FINAL DECISION
TransGrid transmission
determination
2015–16 to 2017–18

Attachment 6 – Capital
expenditure

April 2015

Figure 6-2 Histogram of risk scores

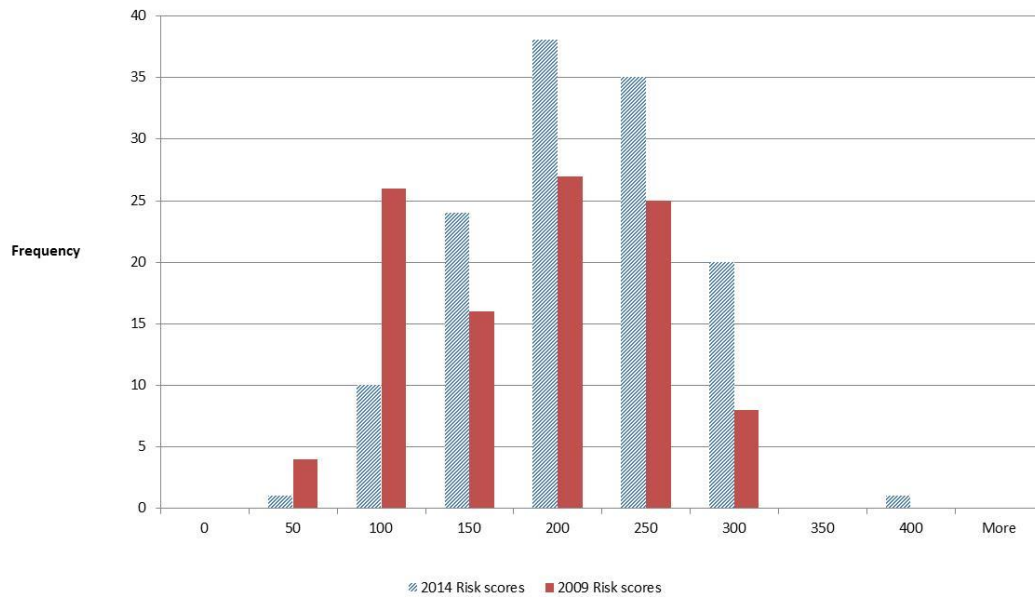
Figure 6-2 shows a histogram of the risk scores presented in TransGrid's revised proposal. TransGrid's data shows that the average and maximum risk scores have both increased between 2009 and 2014. A visual inspection of these risk scores indicates there is a different distribution of risk scores between 2009 and 2014. This is supported by a statistical analysis (a T-test for statistical significance) which indicates that the two sets of risk scores are not drawn from the same population (see appendix E). This indicates that a consistent process was not used to generate the risk scores in the two periods.

Figure 6-3 Relative MTFP performance of transmission networks

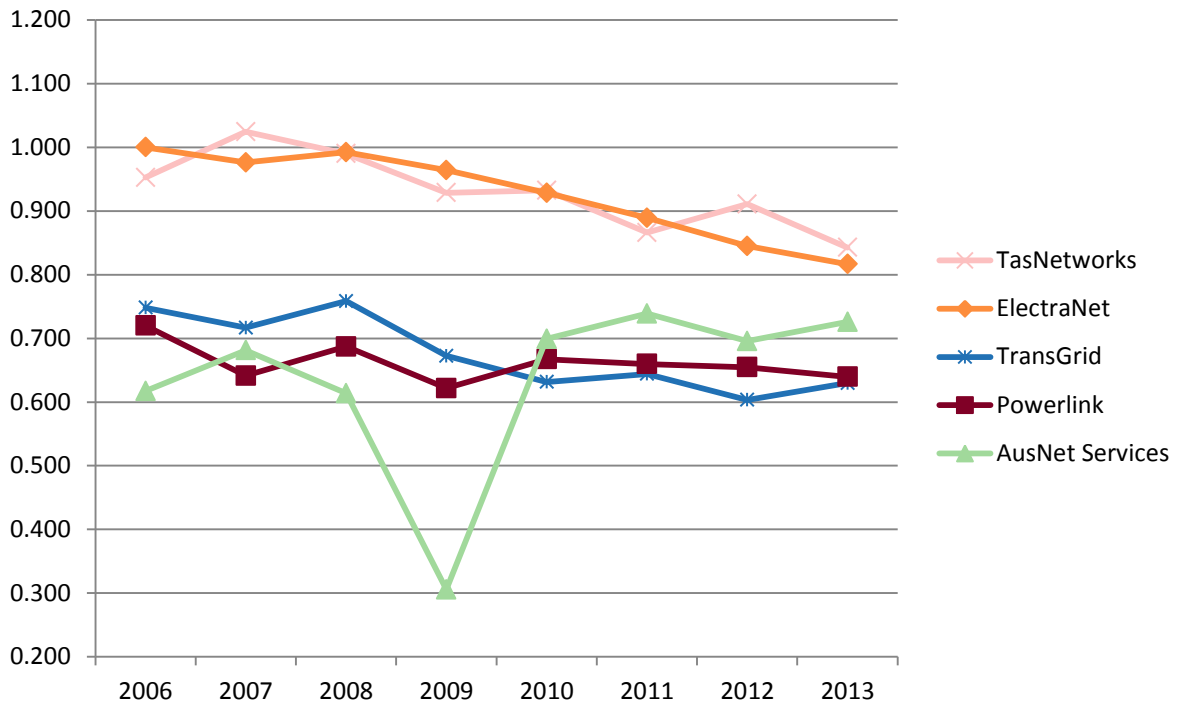
Figure 6-3 shows TransGrid's MTFP performance over time and relative to the other service providers. MTFP measures how efficient a business is in terms of its inputs (costs) and outputs (customer numbers, ratcheted maximum demand, reliability, circuit line length and energy delivered). These results show that TransGrid's efficiency has declined steadily over time.

Figure 6-4 Historic capex and forecast capex for TransGrid (million \$2013/14)

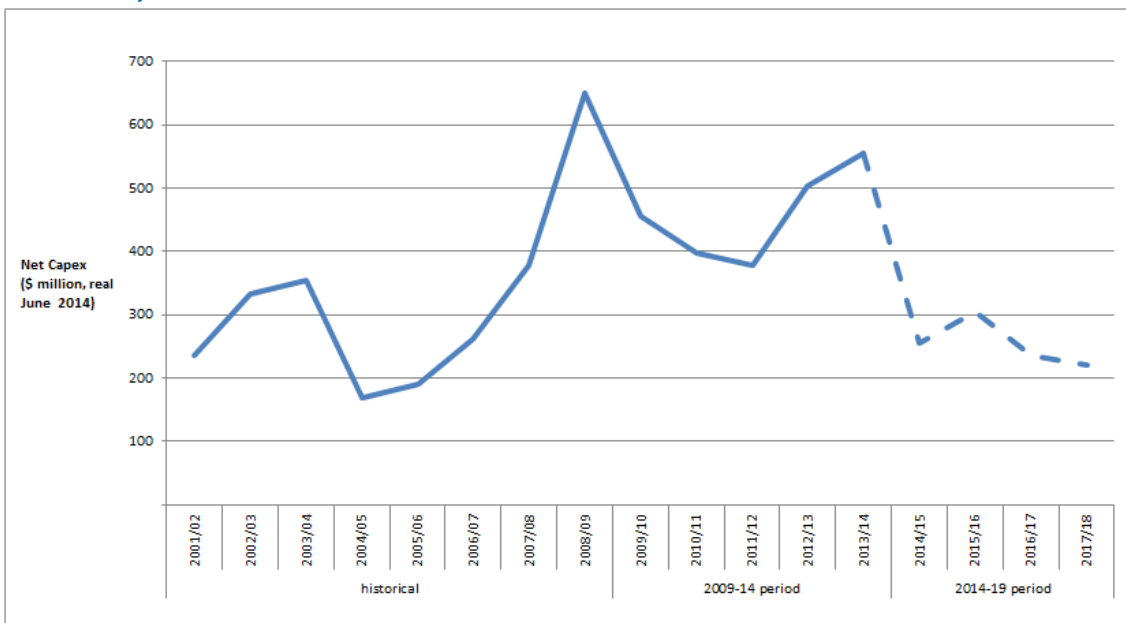
Figure 6-4 shows TransGrid's proposed forecast capex against historical trends (\$2013–14). This indicates that capex is declining when compared to the recent trends. The average annual capex allowance for the 2014–18 period is marginally lower than the average of the capex TransGrid spent between the years 2004–05 and 2013–14.

Figure B-1 Repex actual and forecast trend from 2004–2018 (inflation adjusted)

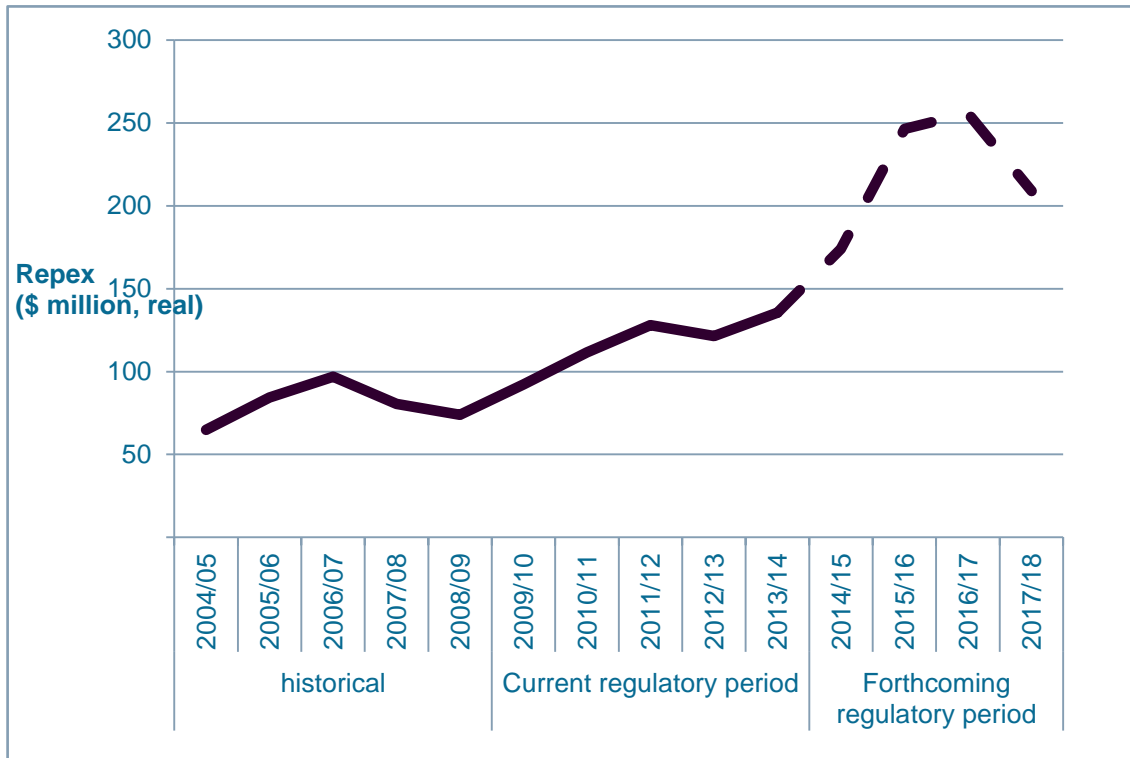
TransGrid's revised forecast average annual repex over the 2014–18 period is \$224.6 million (\$2013–14) per year. This compares to average annual actual repex of \$148 million (\$2013–14) over the 2009–14 period, an increase of 51.8 per cent. In our draft decision we observed that this was a substantial increase compared to the actual capex that TransGrid spent during the 2009–14 period (refer to Figure B-1).

Figure B-2 TransGrid's actual and forecast non-network ICT capex from 2004-05 to 2017-18 (\$million, 2013-14)

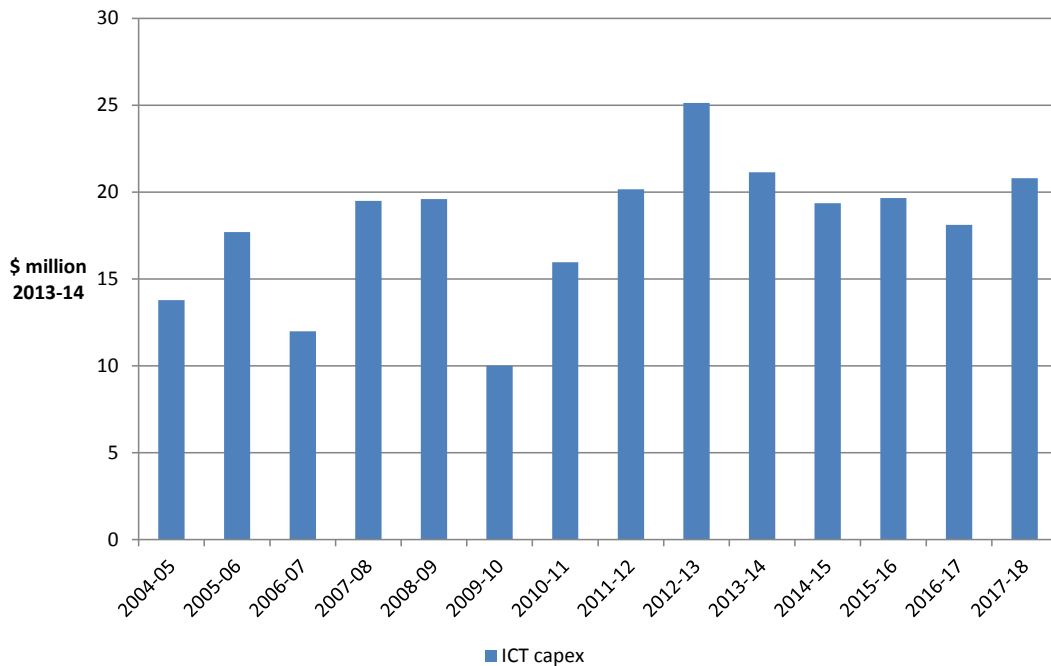
The CCP submitted that TransGrid's forecast ICT capex is around 300 to 400 per cent above its long term historical average. We set out TransGrid's historical and forecast non-network ICT capex from 2004-05 to 2017-18 in Figure B-2 below.

Figure E-1 TransGrid analysis of risk distribution

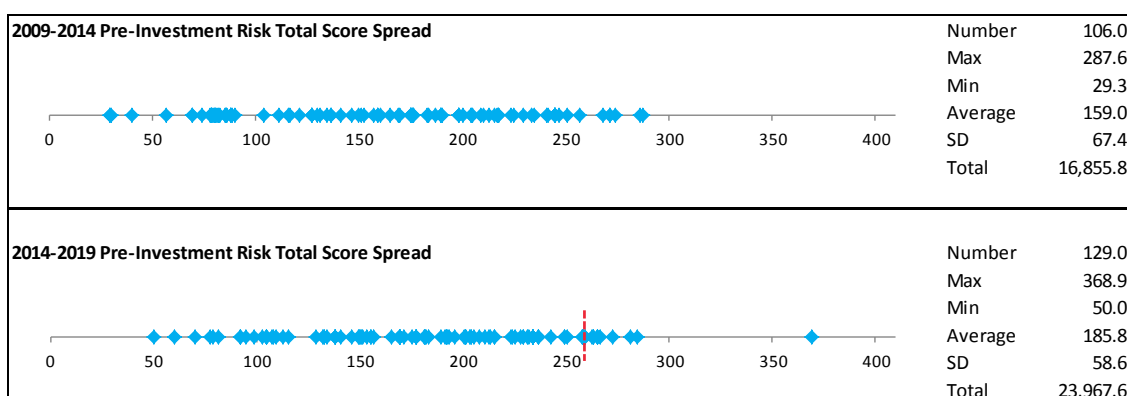
TransGrid presented Figure E-1 to demonstrate that it is undertaking projects with a similar risk profile to the previous regulatory control period. We have analysed the distribution of the risk scores in the 2009-14 and 2014-18 regulatory control periods and conclude that these two risk distributions are not generated by the same process and that TransGrid has inflated its risk scores in comparison to the previous regulatory period.

Figure E-2 Histogram of risk scores

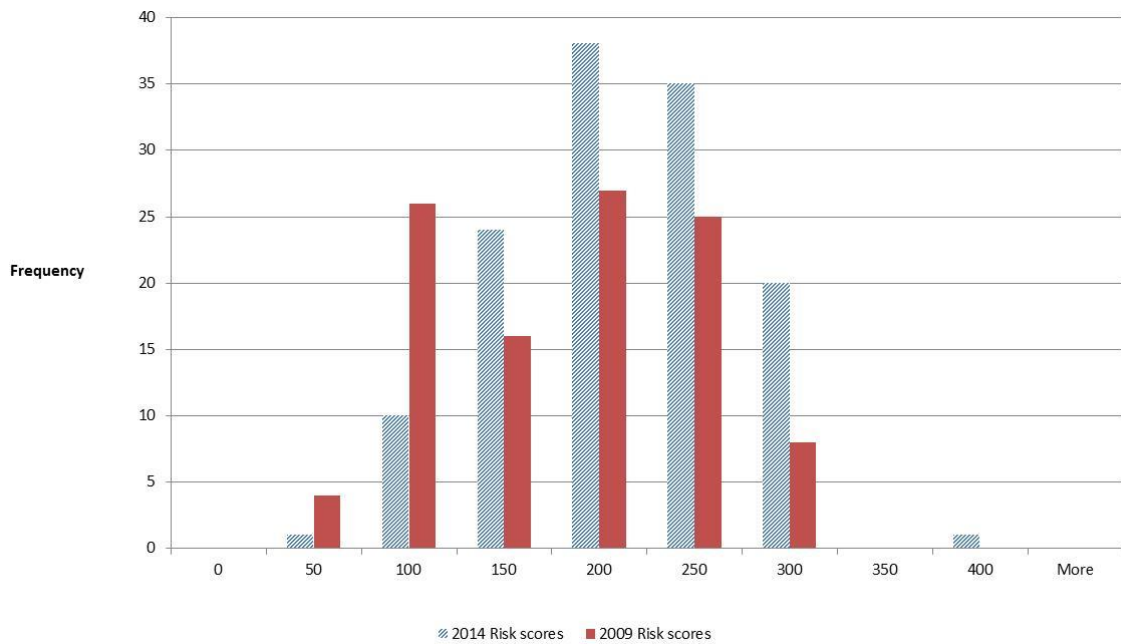
Figure E-2 provides a visual indication that the profile of risk scores in these two periods is different. In 2014 there appears to be a greater proportion of projects with higher risk scores.

Figure E-3 shows the output of a T-test, which can be used to determine if two sets of data are significantly different from each other. This test shows that the risk scores from 2009 and 2014 are significantly different from one another and this demonstrates that TransGrid is not addressing a group of projects with similar risk profiles as contended in its revised regulatory proposal.
